Access Compliance Report

Public Rights-of-Way

(Pedestrian Signals)

Intersection ID: N/A	Main Street:	Cross Street: N/A	Location: N/A
ADA ID: 103FD8DA941A	Signal Type: One Push Button-APS	Overall Compliance: No	Severity Score: BTN 1: N/A BTN 2: N/A No BTN: N/A
Codes/Mitigation Info/Possible Solution		Field Measurements/Component Compliance

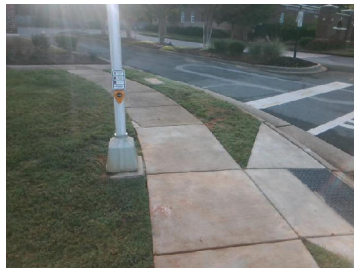
Surveyor Notes: TEXT HT 1/4

PROW/ADA: R410.6, R209.1, TMUTCD 4e.08, R404.2, R404.3, R406.2, MUTCD 4e.10

Possible Solutions: Replace Signal Push Button With APS Button on New Post. Remove & Replace Sign.
